ENVIRONMENTAL REVIEW COMMITTEE REPORT

Project Name: McCormick Plat

File Number: LUA11-034, ECF, PP, V-A, PPUD

STAFF RECOMMENDATION: Staff Recommends that the Environmental Review Committee issue a Determination of Non-Significance - Mitigated (DNS-M).

McCORMICK PLANT MITIGATION PLAN PLANTING SHEET

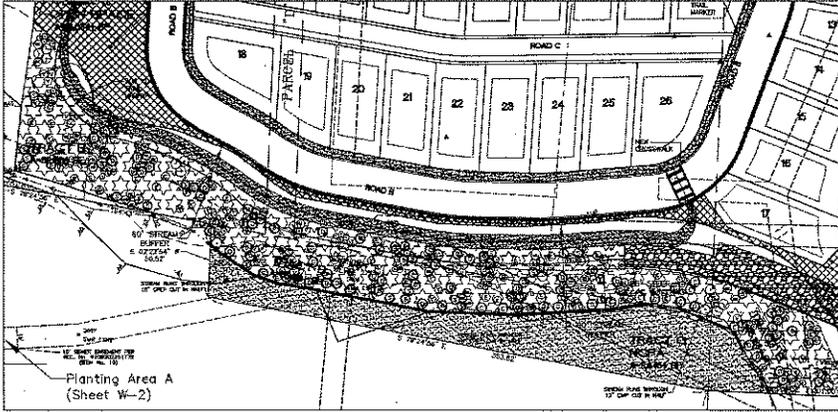
2. *We would also like to see the proposed planting plan for the berm and stream riparian areas described in the revised Critical Areas report to ensure that riparian functions will be maximized.*

The detailed mitigation plan and an updated Critical Area Report dated August 12, 2011 provide this information and show the proposed plantings, habitat materials as well as describe functional lift from the proposed enhancement project. Please find this information attached.
